Model: Adonis-C3		Date: 20-May-03	No.: RB082012
Subject: SR790 Finisher Installation		Prepared by: K. Takagi	
From: 1st Tech. Support Sec. Service Support Dept.			
Classification:	<input checked="" type="checkbox"/> Troubleshooting <input type="checkbox"/> Mechanical <input type="checkbox"/> Paper path <input type="checkbox"/> Other ()	<input type="checkbox"/> Part information <input type="checkbox"/> Electrical <input type="checkbox"/> Transmit/receive	<input type="checkbox"/> Action required <input type="checkbox"/> Service manual revision <input type="checkbox"/> Retrofit information

Subject: Software Release History (SR790)		Prepared by: S. Tomoe	
From: 1st Tech. Support Sec. Service Support Dept.			
Classification:	<input type="checkbox"/> Troubleshooting <input type="checkbox"/> Mechanical <input type="checkbox"/> Paper path <input checked="" type="checkbox"/> Other ()	<input type="checkbox"/> Part information <input type="checkbox"/> Electrical <input type="checkbox"/> Transmit/receive	<input checked="" type="checkbox"/> Action required <input type="checkbox"/> Service manual revision <input type="checkbox"/> Retrofit information

Model: R-C2 / AT-C1 1000 Sheet Finisher		Da

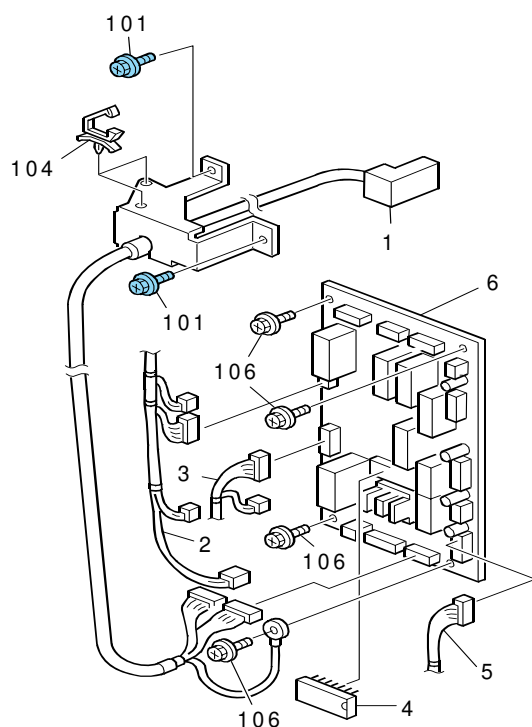
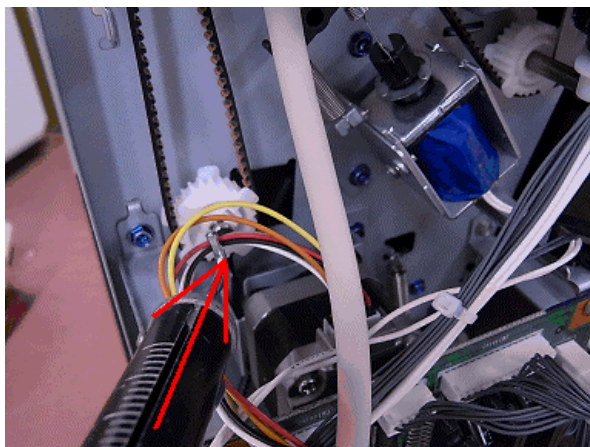
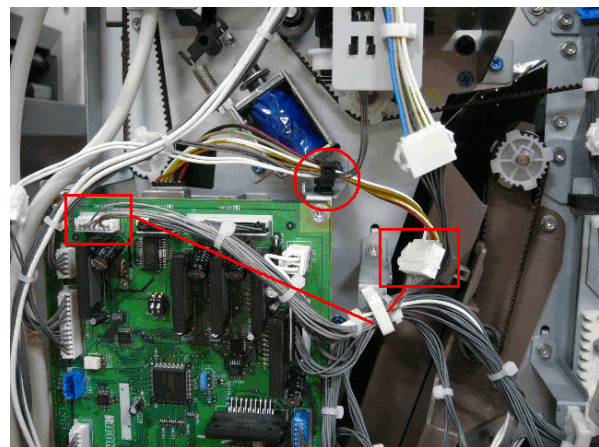
Change:

- 1) The shape of the bracket was changed (a clamp was added to the bracket).
- 2) The routing of the harness was changed.

- 1) To prevent the harness from touching the belt.
- 2) To prevent the harness from touching the gear.

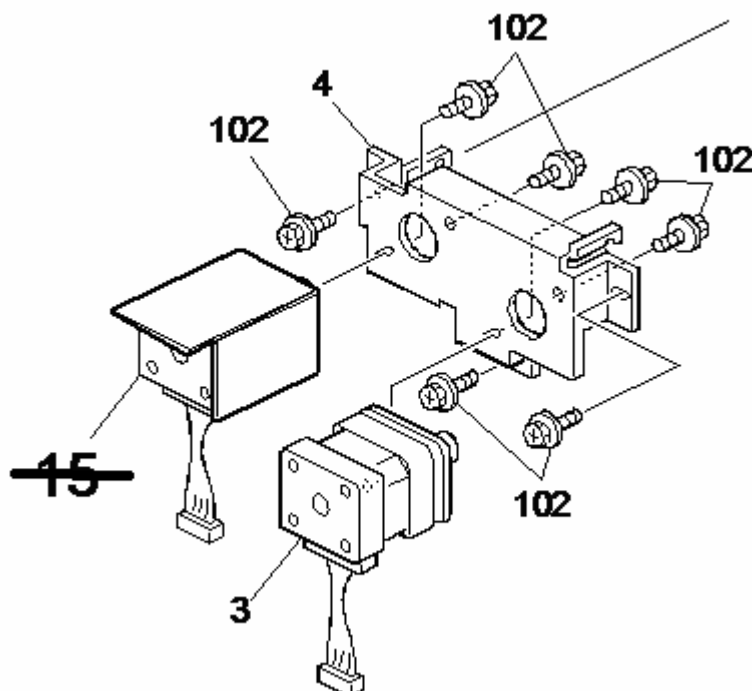
Change: The heat sink shown was deleted.

Reason: It was found that the standards for the machine's internal temperature can be satisfied without this heat sink.

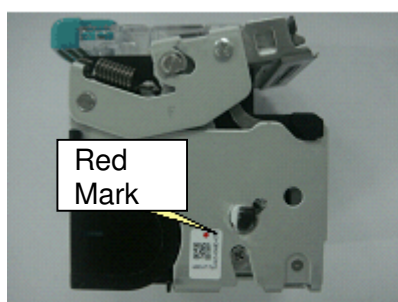
Important: Stapler units on some of these affected finishers have already been replaced with the normal ones. If there is a **red dot** on the stapler unit's label (see the photo below), you **do not need to replace** these units.

The affected stapler unit is shown in the illustration below (Index #24):

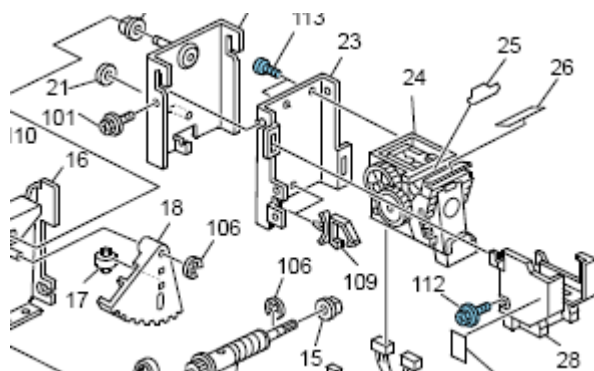
Some parts of the stapler unit (black resin parts shown below) contained PBDE material in excess of the limits set by the RoHS Directive.

The vendor of these parts used irregular materials during the manufacturing process.
 Production period: June to September 2010 (refer to the S/N table below)

Replace the stapler unit.
